Karen Jones
Director Infrastructure projects.
NSW Department of Planning & Environment
GPO Box 39
SYDNEY NSW 2001

This letter delivers the results of Office of Environment and Heritage's (OEH) assessment of the biodiversity and Aboriginal Cultural Heritage impacts associated with Yass Valley Wind Farm, project reference MP08_0246.

Attachment 1: OEH's Assessment of the Biodiversity and Aboriginal Cultural Heritage Impacts Associated with Yass Wind Farm May 2014

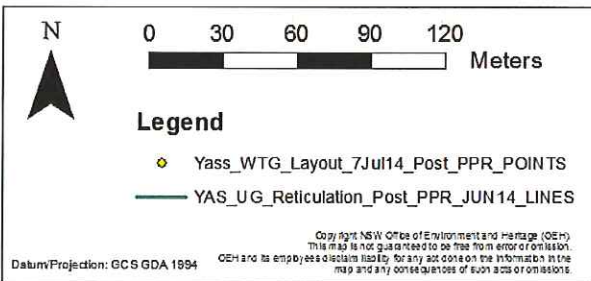
This is in response to OEH's enquiry about why there are numerous turbine locations where the reticulation lines do not lead to the turbine location. The explanation covers most of the turbine locations assessed, except for turbine 100 which is over 65m beyond the end of the reticulation lines (see figure below).
